**ROSEVILLE**  
**REQUEST FOR COUNCIL ACTION**

Item Description: Request by Arthur Mueller, owner of the residential property at 2201 Acorn Road, for approval of a preliminary plat of the property into 4 lots

Preliminary Plat  
of  
OAK ACRES  
for  
Art Mueller

**TREE PRESERVATION PLAN**

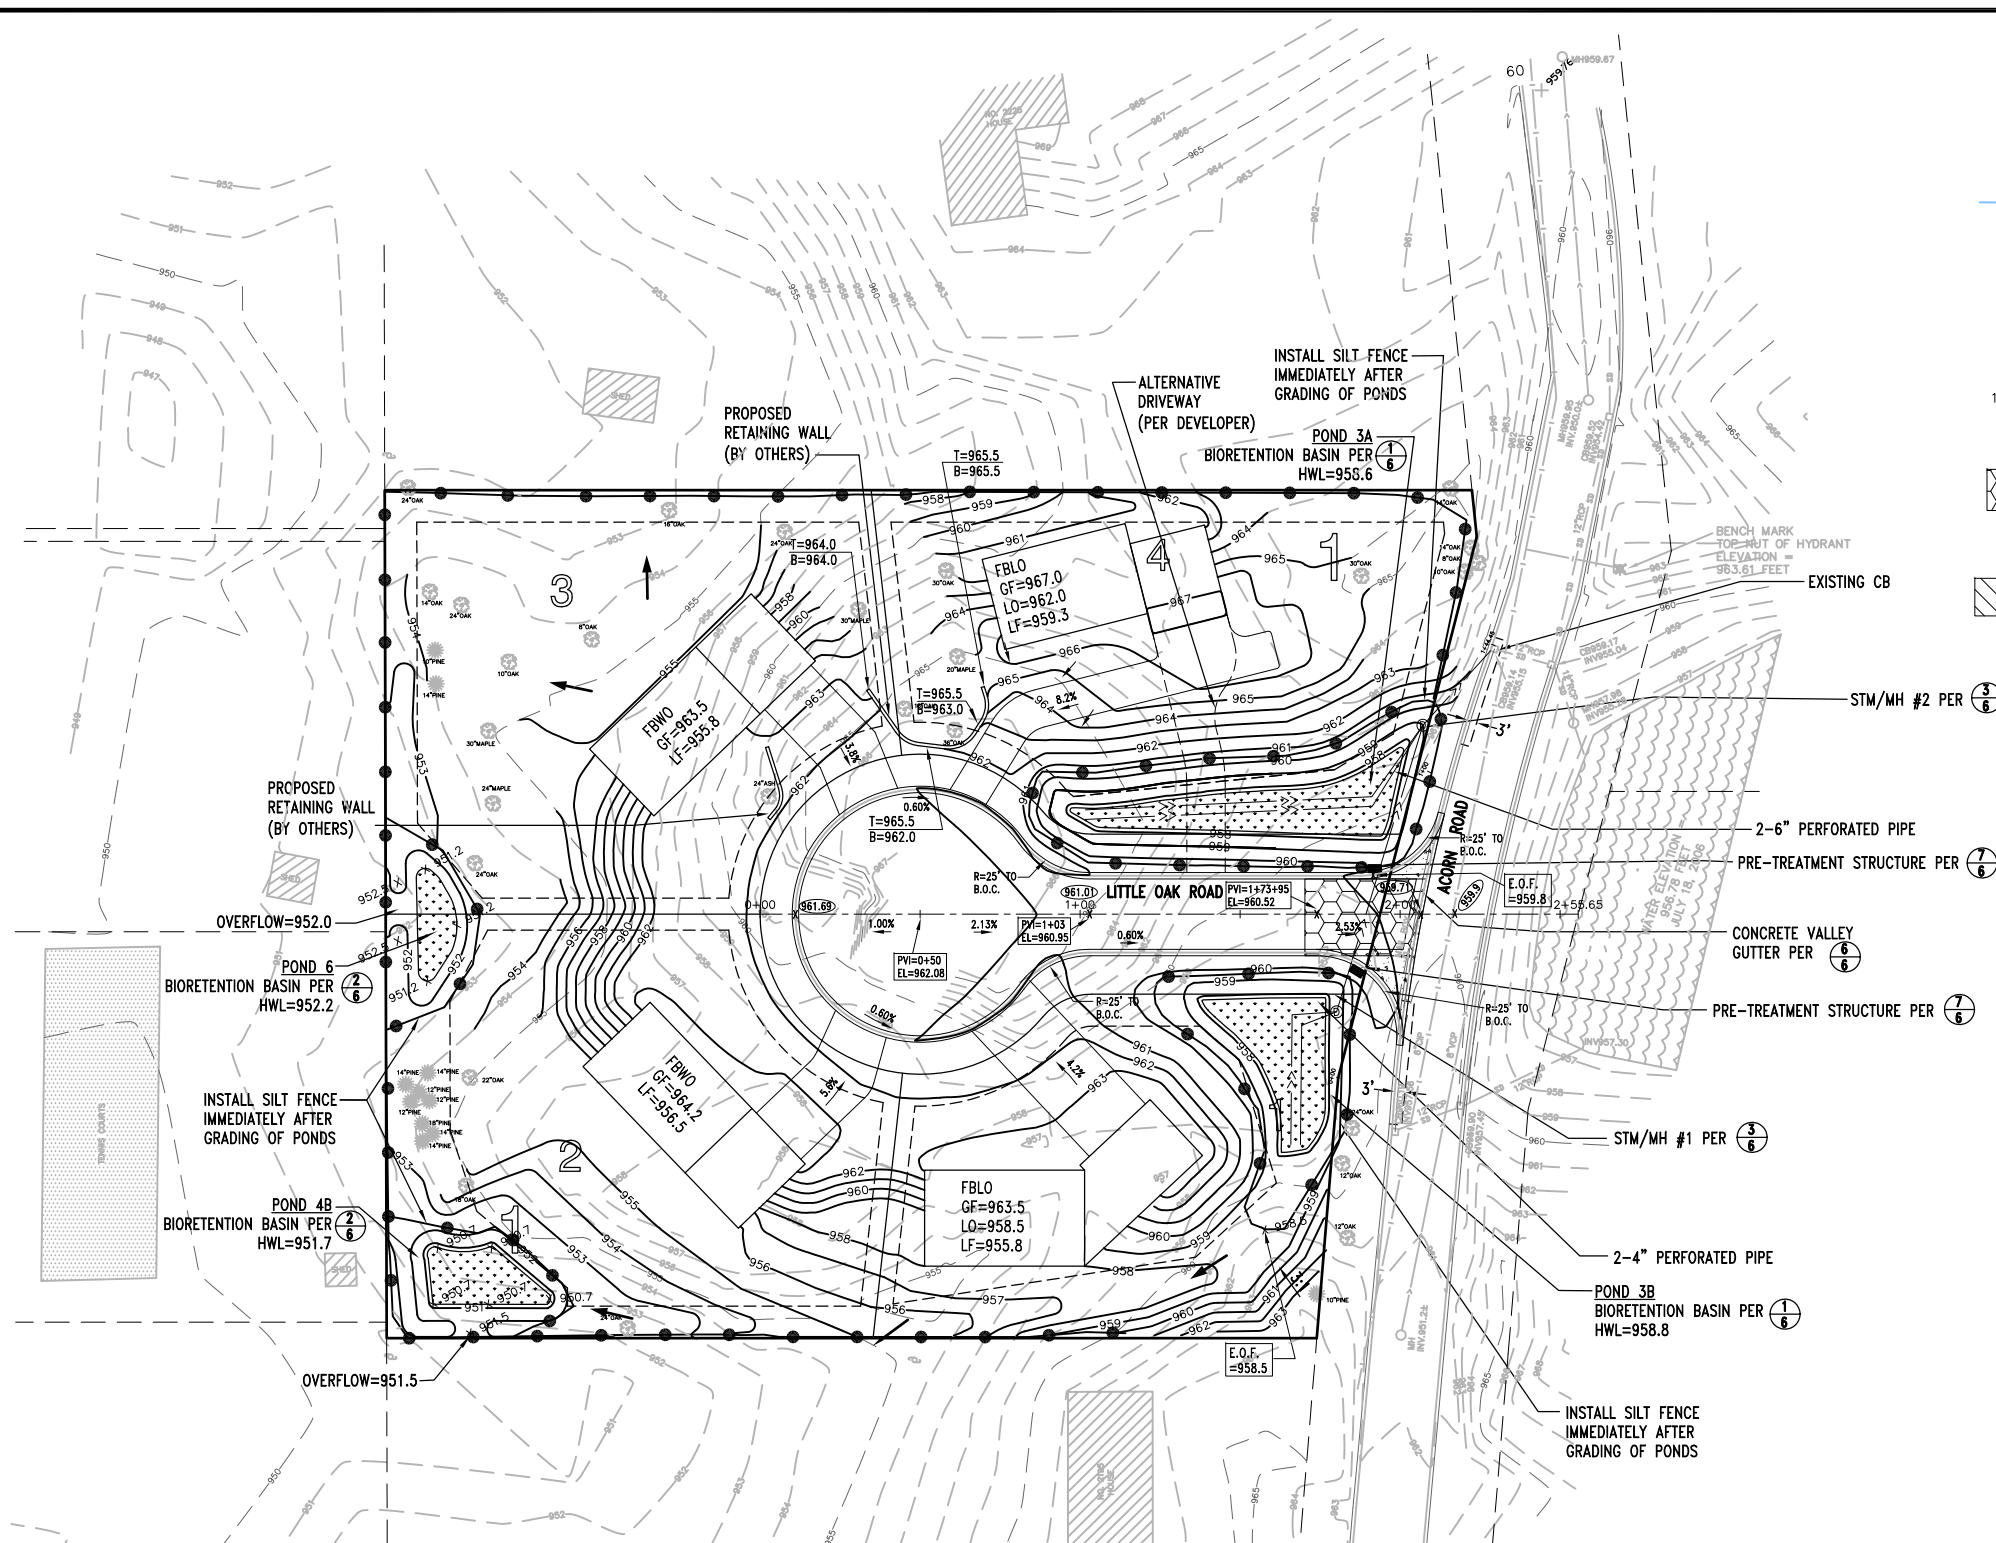
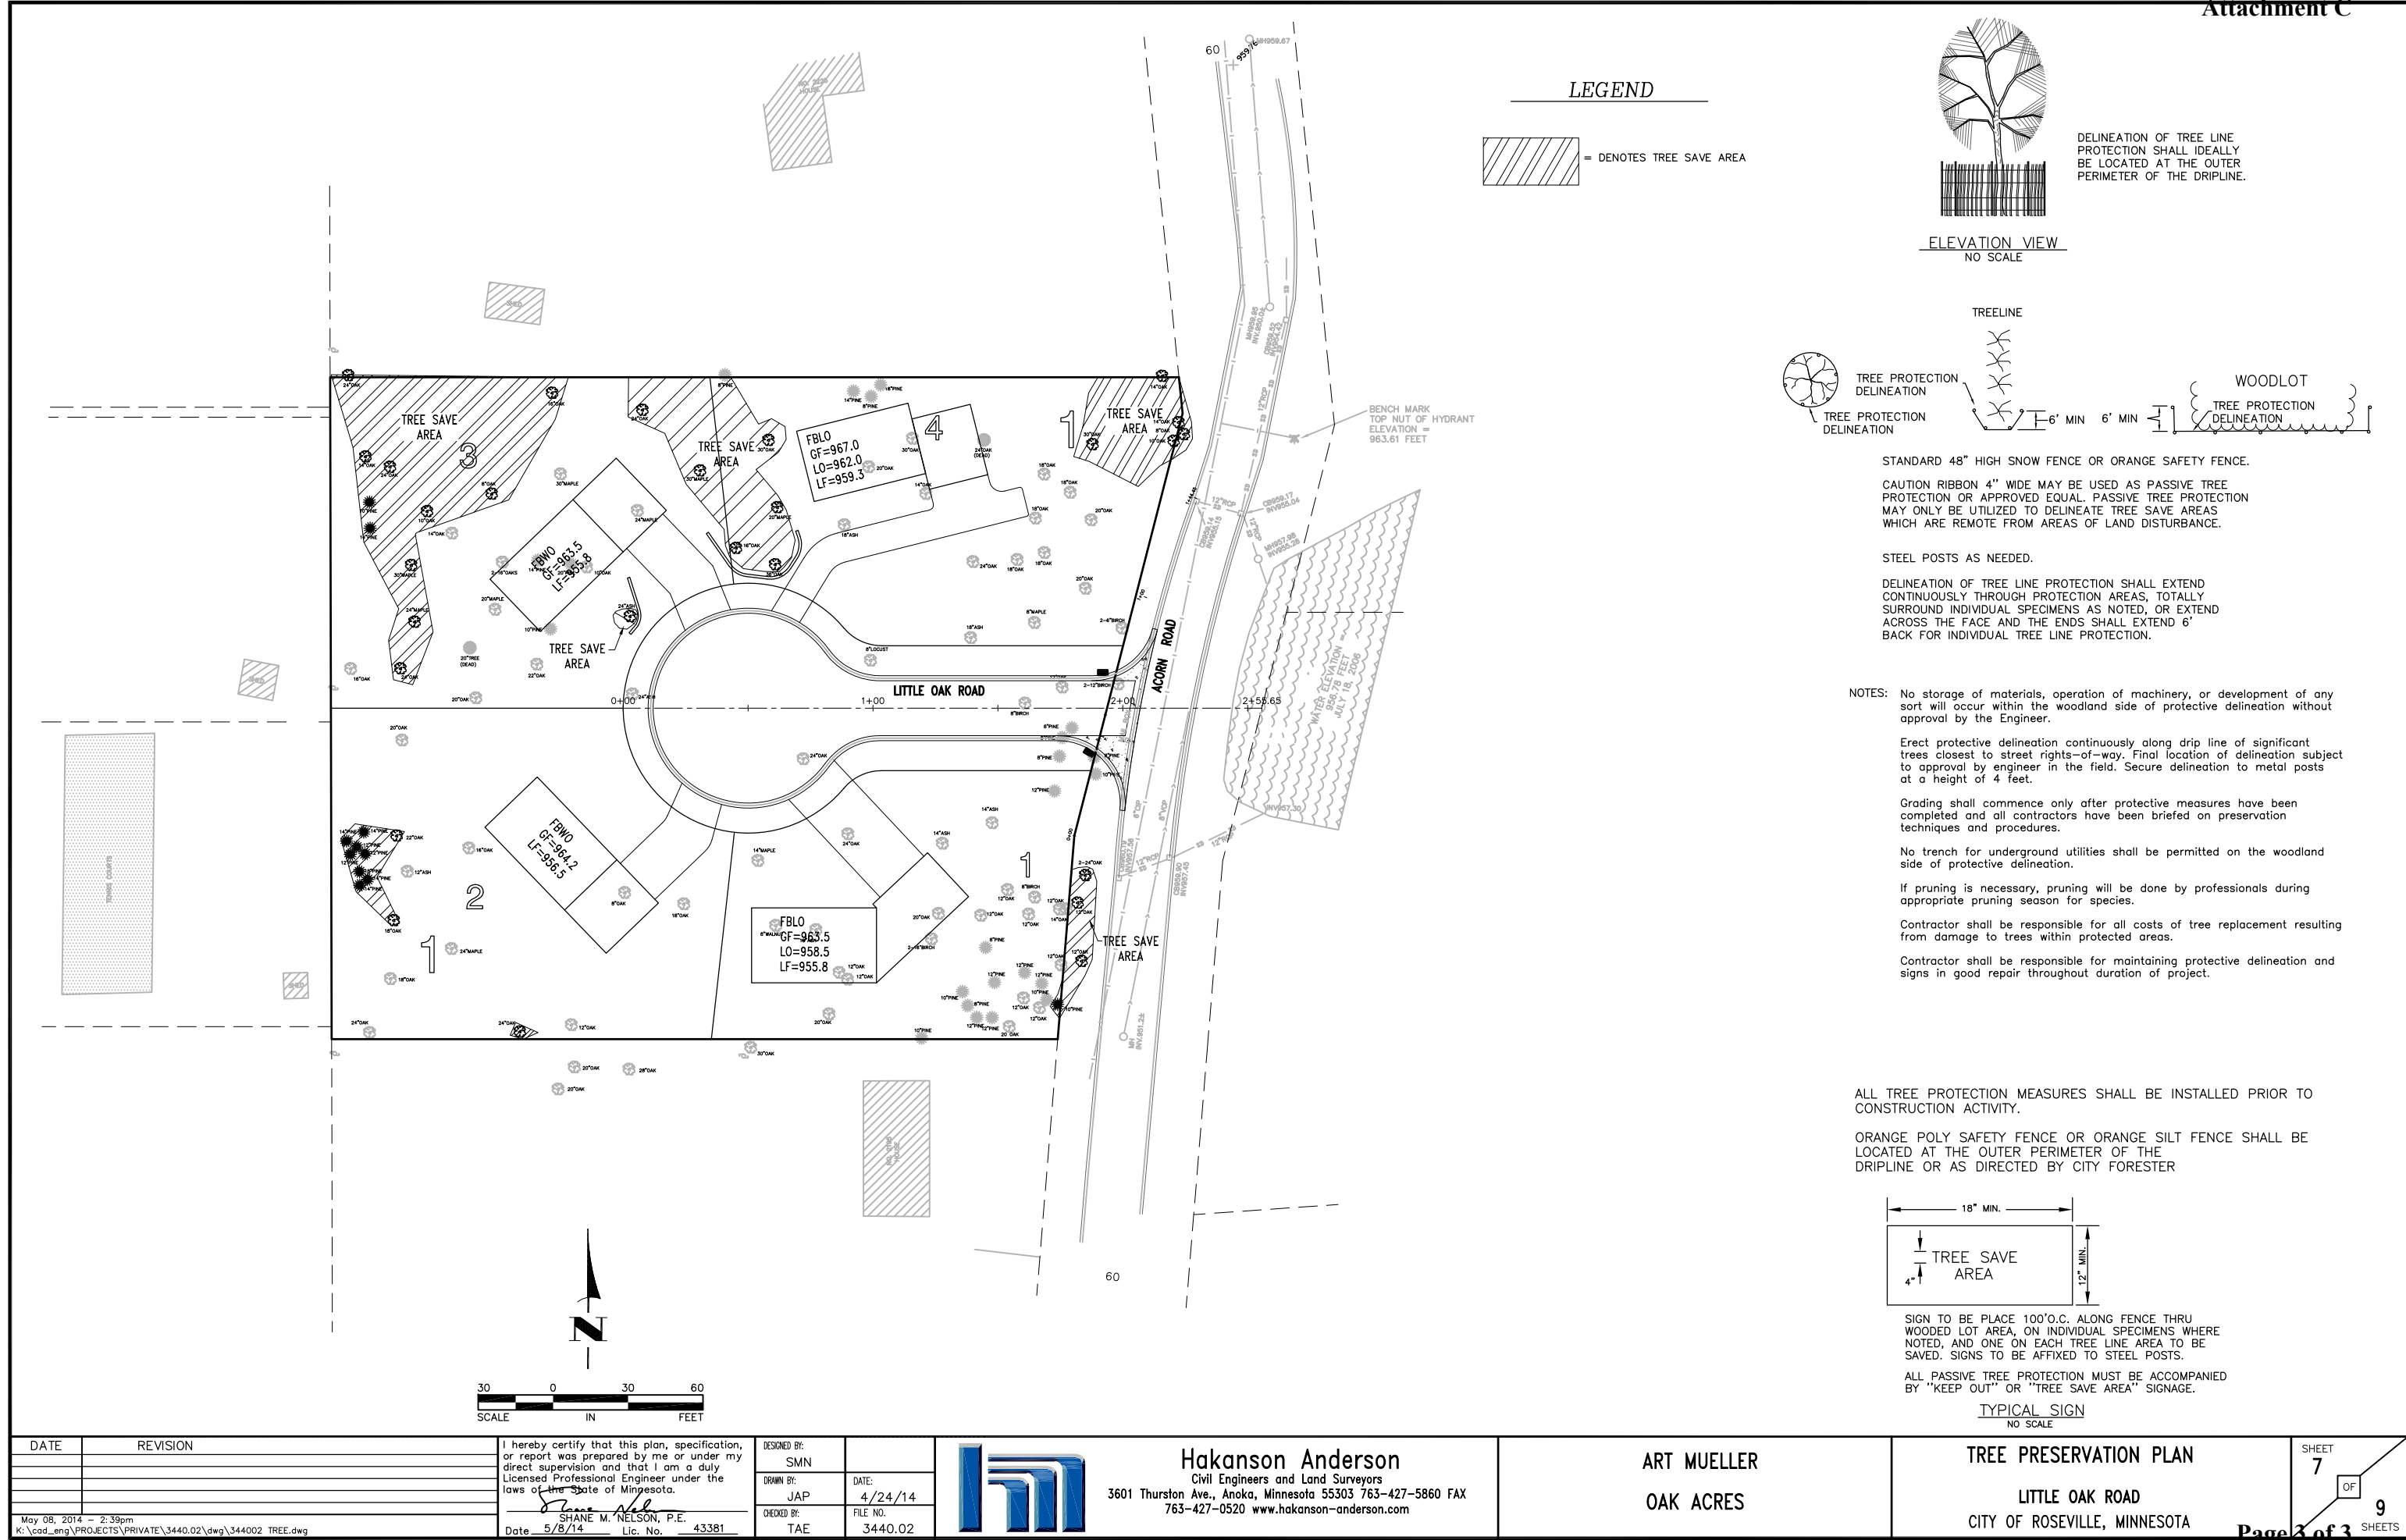
4.4 City Code §1011.04 (Tree Preservation) specifies that an approved tree preservation plan is a necessary prerequisite for approval of a PRELIMINARY PLAT. A tree survey has been provided which identifies the trees on the property as well as the trees which are likely to be removed, based on the current grading plan and generalized locations houses and driveways. While the essential information has been provided, the final tree preservation plan depends upon the final grading plan, which may not be finalized until the final plat; for this reason, it is prudent to proceed with review and possible approval of the PRELIMINARY PLAT with the condition that a final tree preservation be approved concurrent with the final plat.

18 Mr. Lloyd also briefly reviewed Section 5.4 of the staff report related to City Code Section 1011.04 (tree  
 19 preservation), advising that a tree survey had been provided, but was still under review by staff and final  
 20 approval was also a conditional as part of the final plat.

Noting that Mr. Mueller had already removed a considerable number of trees on his property almost immediately after meeting with the Planning Commission in 2007, Ms. Ramalingam questioned the tree preservation aspect in that context and what kind of tree restoration was intended.

In context, Mr. Lloyd noted that a few of the trees around the site were dead, as noted in the applicant's tree preservation plan as presented, and some removals involved those; however, he concurred that staff would be verifying the actual tree inventory on site during the process.

c. Permits for site improvements shall not be issued without approval of a final tree preservation plan, accounting for any impacts not yet anticipated, by the Community Development Department.
